04/17/2020
CAL FTL 32-004

Subject: 80KSI Frame Reinforcement Installation

Models Affected: Specific 2020 model year Freightliner M2 vehicles manufactured between May 28, 2019 and October 06, 2019 equipped with 80KSI frame rails and an Airliner 21,000 lb rear suspension

Fig. 1, View From Inside of Right-Hand Rail

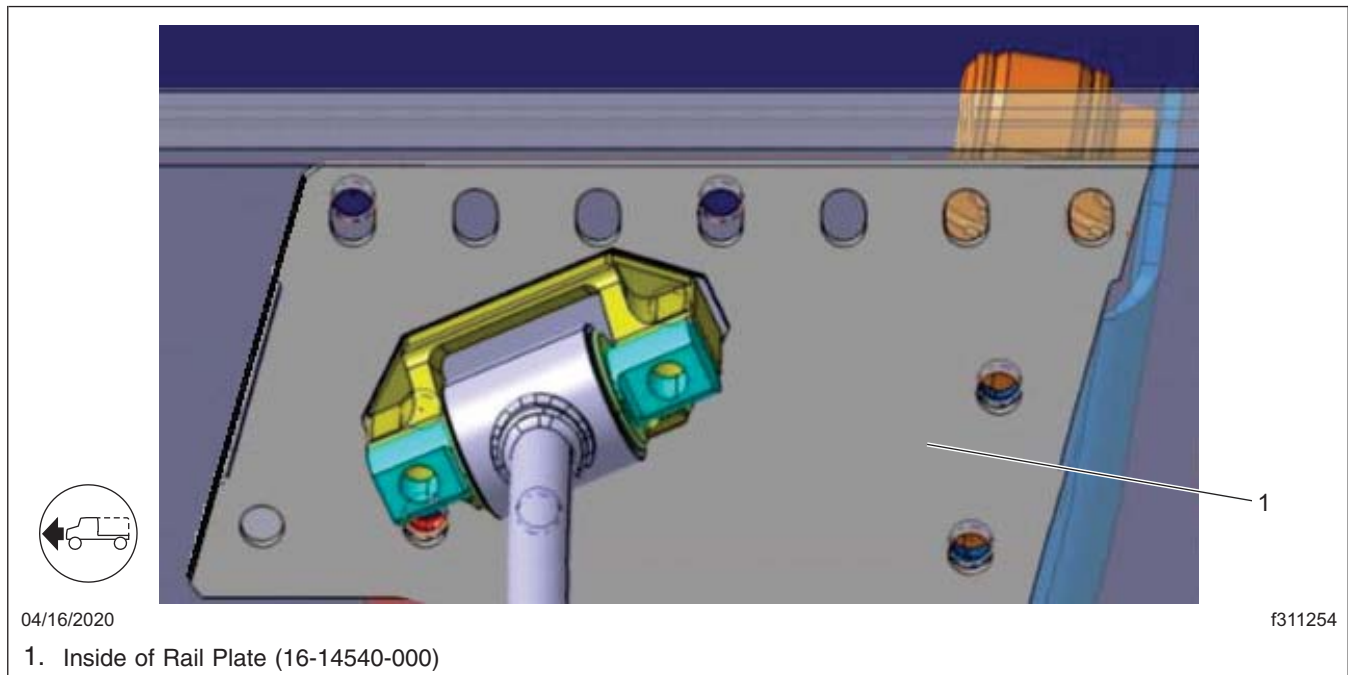
8. Align the inner reinforcement plate (16-14540-000) with the shock bracket mounting holes on the inside of the right-hand frame, then attach the shock mounting bracket to the frame and inner reinforcement plate using the two 2 in long 5/8 in bolts, nuts, and washers. See [Fig. 1](#). Tighten the bolts hand tight only.

Fig. 2, View of Installed Washer

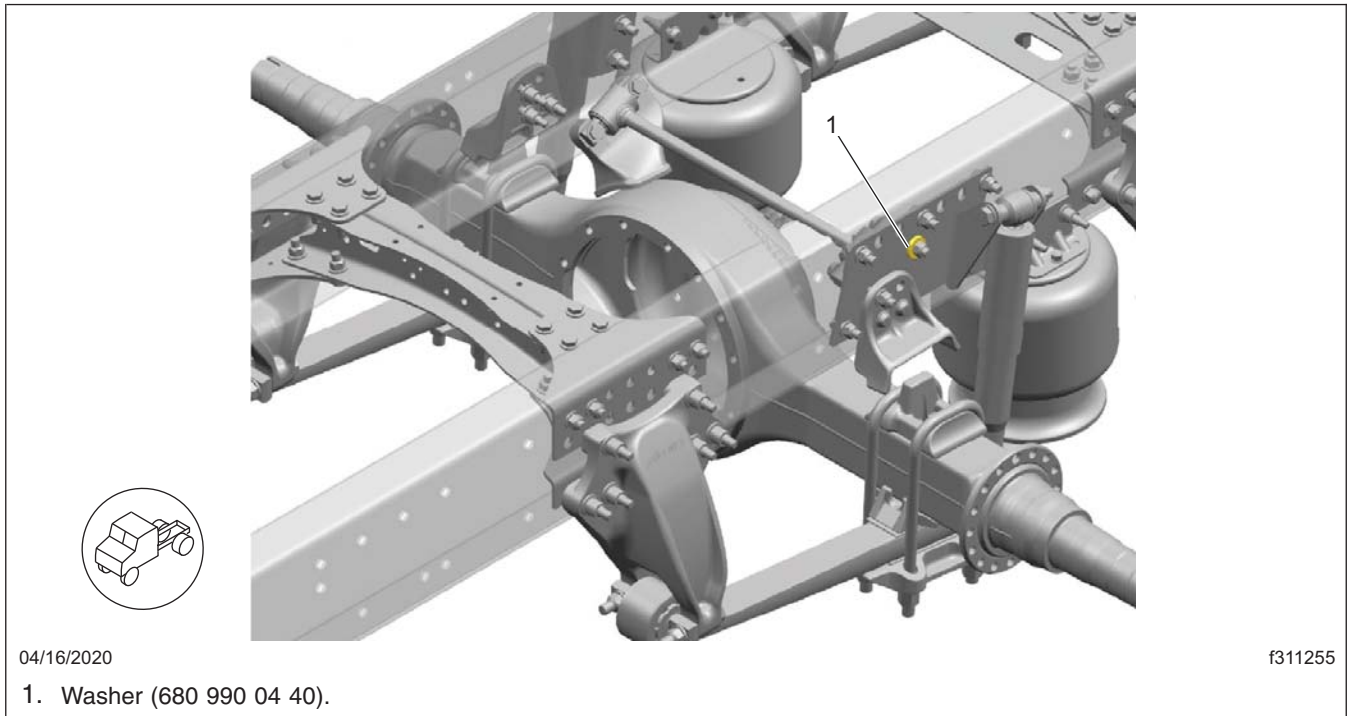
9. Attach the bump stop through the two lower mounting holes using the two 2-3/4 in long 5/8 in bolts, nuts and washers. Tighten the bolts hand tight only.
10. Attach the transverse torque rod and bracket using the two 5 in long 5/8 in bolts, nuts and washers. Insure the washer (680 990 04 40) is installed as shown in **Fig. 2**.
